# Product Change Notification

### **Bourns® Model SRN8040 Semi-Shielded Power Inductor Series Change to Packaging Specification, Minimum Order Quantity and Multiple Ordering Quantities**

**Figure 1 - Current Carrier Specification**

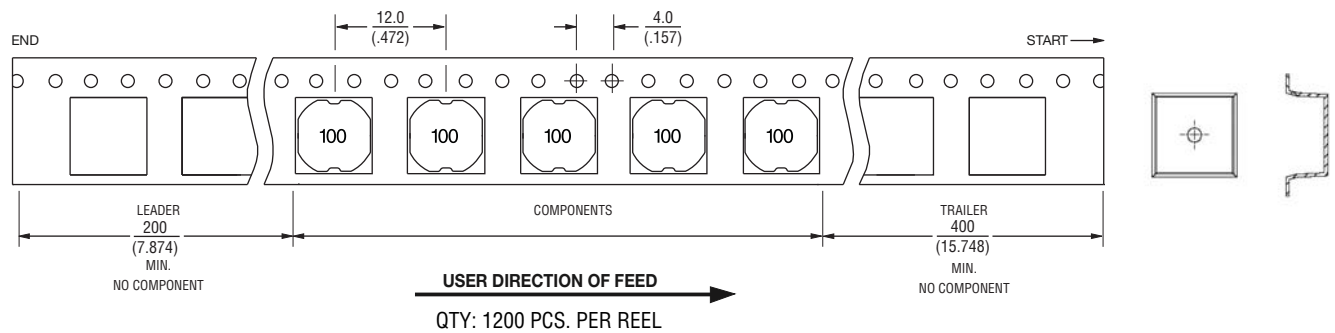
The packaging specification of the tape and reel carrier of the Model SRN8040 has been redesigned with embossment on the bottom and sides to provide shock absorption in order to help protect the inductor during shipping and handling. Along with this change, the tape leader, trailer and the number of inductors packaged per reel has been modified. Figures 1 and 2 highlight these changes. The MOQ and MULT ordering quantities of the Model SRN8040 Series have changed from 1200 pcs to 1000 pcs.
